Office Action Summary	Application No.	Applicant(s)	
	10/563,338	LAGLER, LOUIS	
	Examiner	Art Unit	
	ANDREW T. KIRSCH	3781

DETAILED ACTION

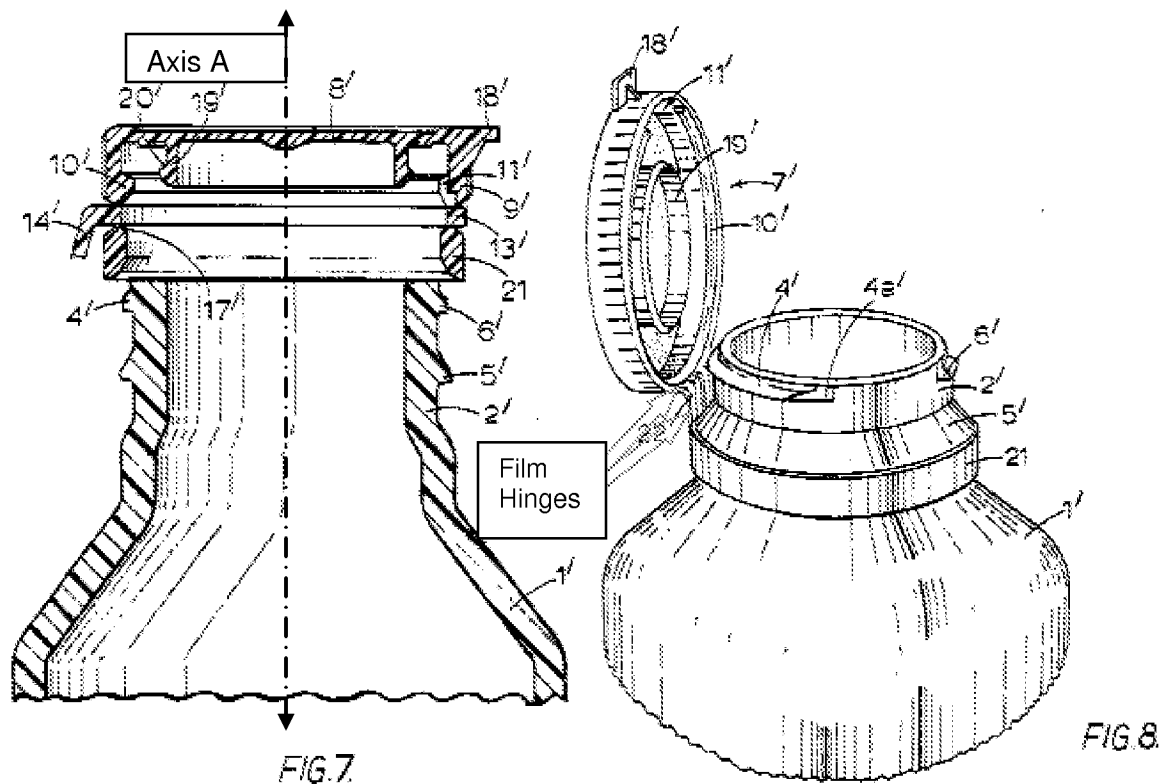
9. In re Claim 1, with reference to Figs. 7 and 8 below, Wheeler discloses: A closure moulded in closed position with

- a ring shaped body (21), the ring shaped body having an opening extending in an axial direction and having substantially the same diameter at both ends (see Fig. 7), comprising fixing means (17) to fix the closure on a neck (2') of a bottle (1'), the fixing means having substantially the same diameter as the opening (see Fig. 7), and

- a lid (7), the lid having substantially the same diameter as the ring shaped body (see fig. 7), the lid comprising a sealing means (19', 20') to seal an orifice (2') of the bottle, the sealing means directly contacting the neck of the bottle (column 3, lines 52-54), and

• a snap hinge comprising a first element (22) and a pair of film hinges (see Fig. 8) defining a plane, the pair of film hinges connecting the first element (22) to the lid (7) and to the body (21), whereby the plane is arranged substantially parallel to an axis A (Fig. 7) of the closure, the film hinges being defined on the outside by a cylindrical boundary surface having a radius R3 (at 21).

Fig. 7 of Rentsch et al.

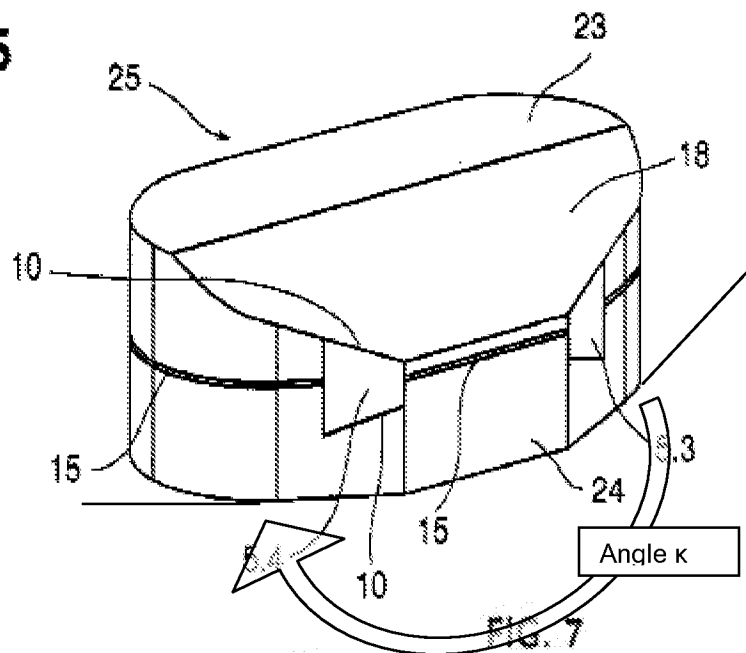
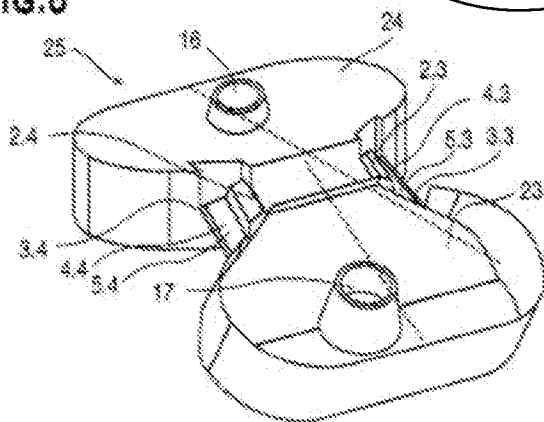
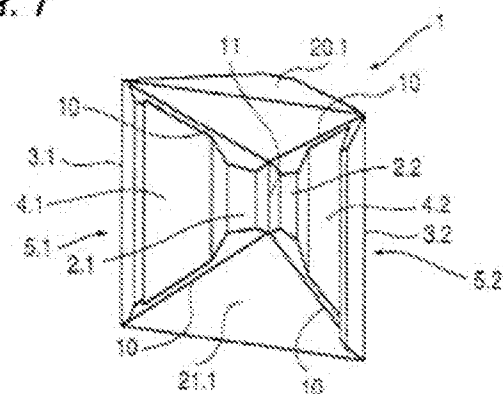
11. However, with reference to Figs. 6 and 7 below, Rentsch et al. discloses a closure wherein a snap hinge comprises a first and second trapezoid element (5.3, 5.4), and a second pair of film hinges (10) defining a second plane, and whereby the inside of each film hinge is defined by a plane (at 4.3 and 4.4) on the inside of the closure and the outside of the film hinge is defined by two flat boundary planes (at 5.3 and 5.4) arranged at an angle κ to each other.

22. In re Claim 6, with reference to the Figs. above, Wheeler in view of Rentsch et al. and Smith et al. discloses wherein the trapezoid elements (5.3, 5.4) are spaced apart by a cutout (see Fig. 5 of Rentsch et al.).

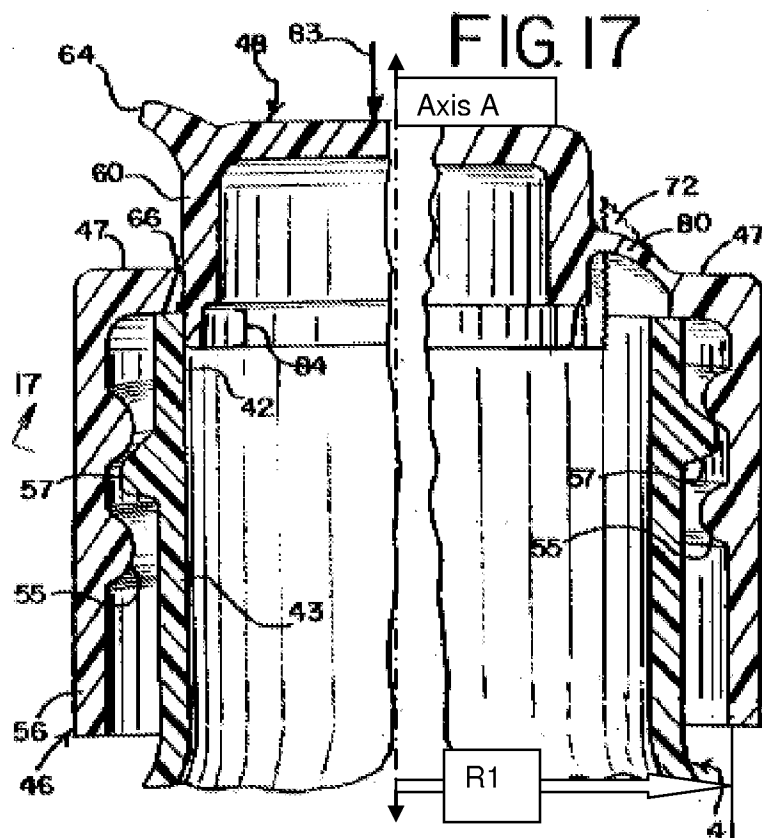
14. However, with reference to Fig. 17 below, Smith et al. discloses a one piece closure which is molded in the closed position in which the inner periphery of the film hinge (80) and an inner periphery of the closure (84) do not extend outward beyond a maximum inner radius R1 of the closure (see Fig. 17 below).
